MEMORANDUM

SUBJECT: **I-241-01 CS Beef Packers, LLC, Staff Analysis supporting reuse permit issuance**

Executive Summary

Figure 8. CSBP monitoring wells proposed in Technical Report (HDR 2016b).

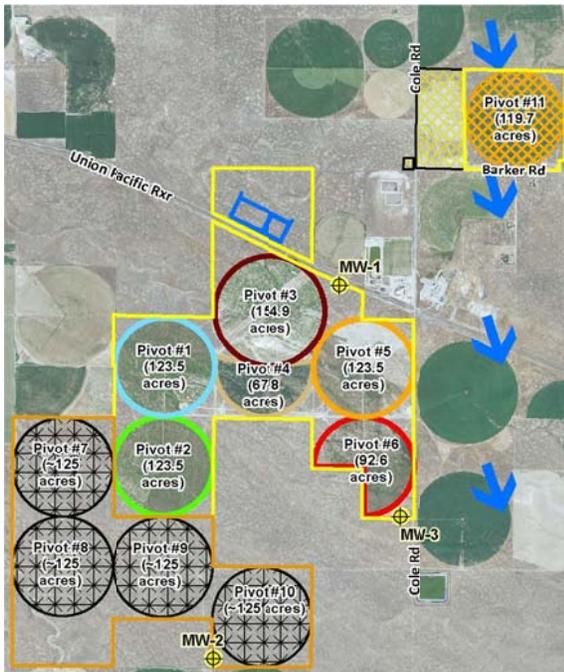
Staff recommends CSBP install an initial ground water monitoring network due to the limited ground water quality data available, estimated loadings (see Section 4.8), leaching necessary as part of good irrigation practices, uncertainty of travel times through fractured basalt, lack of clay or confining layers between ground surface and first water, and preliminary ground water modeling indicating potential increases in TDS and nitrate. In ground water, TDS is a measurement of salt, while in recycled water non-volatile dissolved solids (NVDS) can be used as a rough estimate of salt content. Salts are discussed further in Section 5.8. Preliminary ground water modeling using DEQ’s Water Reuse/Land Treatment System Modeling spreadsheets indicates nitrate and TDS concentrations in ground water may increase from reuse activities. However, without site specific loadings and ground water data, the model could not be calibrated. The draft permit requires a nitrate and NVDS study as a compliance activity, which must include identifying and quantifying sources of nitrate and NVDS in all streams used for land application on the reuse sites, evaluating the relationship between NVDS and total dissolved inorganic solids (TDIS), analyzing the net nitrogen and net salt loading to each reuse site, and modeling the potential ground water impacts. Staff also recommends monitoring common ions in ground water during the first year of the permit and the fourth year of the permit. Common ions can be used to determine the chemical signatures of the ground water from each well. As part of the future permit renewal application process, staff recommends evaluating whether CSBP needs to reduce TDS and/or nitrate loading through source reduction strategies and/or increasing land application acreage.

The Technical Report recommended an initial ground water monitoring well network consisting of three (3) wells completed in the upper aquifer with proposed locations shown in Figure 8. The proposed upgradient well is southeast of the storage lagoons and LSAS. However, the proposed upgradient monitoring well should be located upgradient of the storage lagoons and the LSAS. CSBP did not propose monitoring wells upgradient of Pivot 11 or around the anaerobic, aerobic, or brine lagoons at this time. There are two existing monitoring wells near Pivot 11 from former permit LA-000055. One existing monitoring well is east of Pivot 11 and one existing monitoring well is at the southern boundary of Pivot 11, designated as MW-4 and MW-3 in Figure 6, respectively. Staff recommends monitoring these wells if possible. As a compliance activity, the draft permit requires CSBP to prepare plans for one upgradient and two downgradient monitoring wells in the upper aquifer and to install the monitoring wells after receiving approval of the plans from DEQ. The draft permit includes a compliance activity requiring CSBP to perform a hydrogeological characterization and prepare a ground water monitoring plan, which is required to include the following:

- 1) Determination of ground water depth and flow direction.
- 2) Establish background ground water quality.
- 3) Determination of aquifer characteristics required for ground water modeling, including testing each monitoring well to determine hydraulic conductivity.

- 4) Prepare an updated WLAA. The preliminary WLAA relied on the ground water flow characteristics from the former permit LA-000055. Once the permittee has determined gradient, flow direction, and hydraulic conductivity of the initial ground water monitoring well network, the WLAA can be updated.

- 5) An evaluation of the initial ground water monitoring well network to determine if the wells provide sufficient coverage for assessing upgradient and downgradient ground water quality of the reuse sites. Staff recommends quarterly sampling of ground water monitoring wells for a minimum of two years/eight sampling events. If the evaluation determines the initial ground water monitoring well network is inadequate because it does not provide sufficient coverage, then

Figure 11. Estimated annual NVDS loadings and crop uptakes.

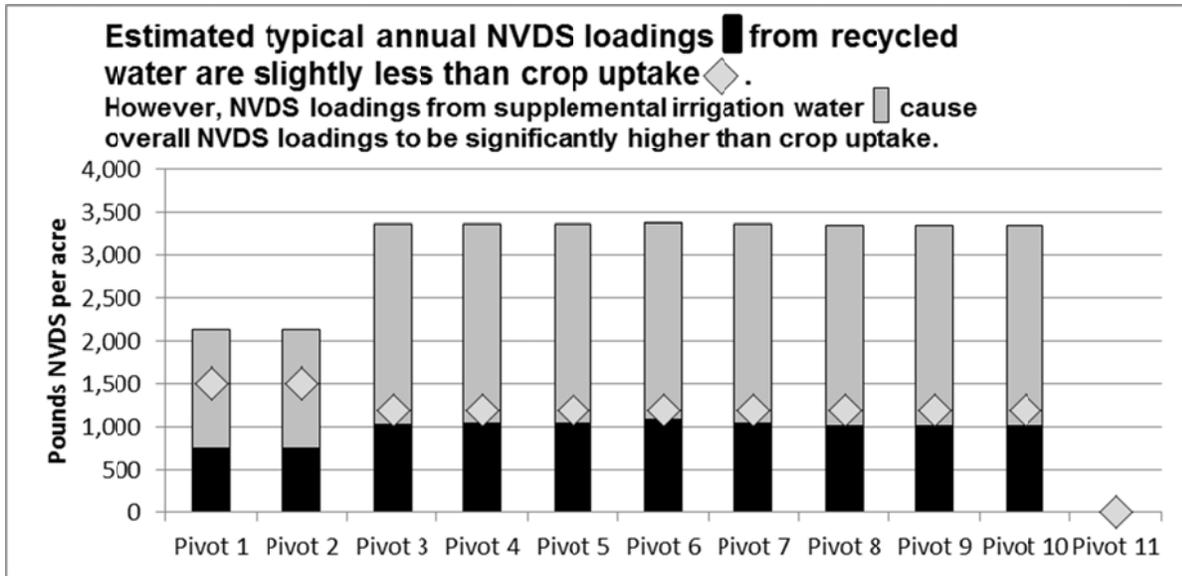
The NVDS loading was estimated based on data from Caviness' facility in Texas and assumes NVDS is not removed through the treatment process. The estimated NVDS loadings from recycled water are less than the estimated crop uptakes for silage corn (Pivots 1 and 2) and alfalfa (Pivots 3 through 10), as shown in Figure 11. However, the NVDS loading from the supplemental irrigation water combined with the loading from recycled water, is significantly higher than the estimated crop uptakes for both silage corn and alfalfa. HDR completed ground water modeling for NVDS as discussed in Section 4.5. This is a new facility and there are many assumptions and uncertainties associated with the estimates. The Technical Report indicates nitrogen is the limiting constituent and NVDS loadings will be limited due to the nitrogen permit limit. CSBP has requested no permit limit for NVDS at this time and has recommended the permit require a NVDS study over a three year period. This study would assess NVDS makeup and concentrations, loadings, and ground water conditions. CSBP would then make recommendations for appropriate NVDS management. The draft permit includes a compliance activity to conduct a salt study as indicated in Sections 5.8 and 9. Staff recommends the future permit renewal process evaluate whether or not NVDS loading limits should be implemented.

Estimated salt loadings, from recycled water and supplemental irrigation water, are significantly higher than estimated crop uptake as shown in Figure 11. The Technical Report included preliminary ground water modeling of NVDS using DEQ's Water Reuse/Land Treatment System Modeling spreadsheets. The model was run for recycled water plus supplemental irrigation water as well as for supplemental irrigation water alone. The upgradient TDS

The Technical Report recommended the permit include a NVDS study as a compliance activity to assess NVDS makeup and concentrations, loadings, and ground water conditions. The draft permit requires CSBP to perform a hydrogeological characterization and prepare a ground water monitoring plan as discussed in Section 4.5. The results can be utilized to model potential NVDS impacts to ground water. The draft permit requires a Nitrate and NVDS study as a compliance activity as discussed in Section 4.5. Time is required for CSBP to complete constructing the facility, to operate the facility, to collect data, and to prepare the hydrogeological characterization and ground water monitoring plan. The draft permit requires the nitrate and NVDS study to be submitted to DEQ for review and approval within 42 months of permit issuance. This should provide DEQ time to review the nitrate and NVDS study prior to the pre-application workshop to be held 48 months after permit issuance.
